CLIO II

88 CONDITION OF INSTRUMENT PANEL WIRING: HELP WITH FAULT FINDING

Fig. 1

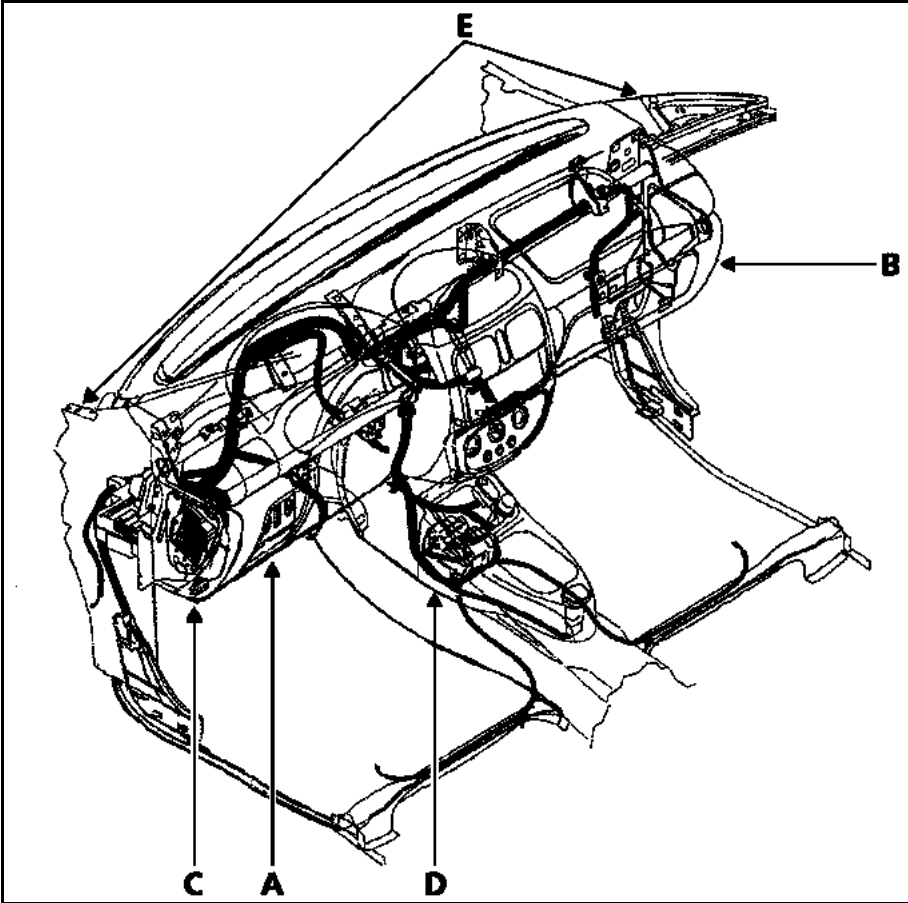
CUSTOMER COMPLAINT	POSSIBLE CAUSE	OPERATIONS TO BE CARRIED OUT
Fuel level indicator remains at zero.	Instrument panel wiring touching the: <ul style="list-style-type: none">– steering column mounting at (A) (Fig. 1),– instrument panel casing retaining bracket on the right-hand side at (B) (Fig. 1).	Test the wiring at (A) and (B) (Fig. 1) with repair or replacement if necessary. NOTE: protect the wiring in the contact zone
Malfunction of the centralised door locking function and the WARNING function (with brief illumination of the door opening indicator light).	Instrument panel wiring touching the: <ul style="list-style-type: none">– clutch pedal area at (C) (Fig. 1),– "OBD2" (On Board Diagnostic) socket mounting at (D) (Fig. 1).	Test the wiring with repair or replacement if necessary. 1) Attach the wiring to the air pipe using strap clips to prevent this from coming into contact with the clutch pedal. 2) Remove the "OBD2" (On Board Diagnostic) socket mounting burrs. NOTE: protect the wiring in the contact zone

Absence of radio noise on the tweeters.	Instrument panel wiring touching the tweeters and the instrument panel casing at (E) (Fig. 1).	Test the wiring with repair or replacement if necessary. Reposition the tweeter wires to prevent any feedback. NOTE: protect the wiring in the contact zone
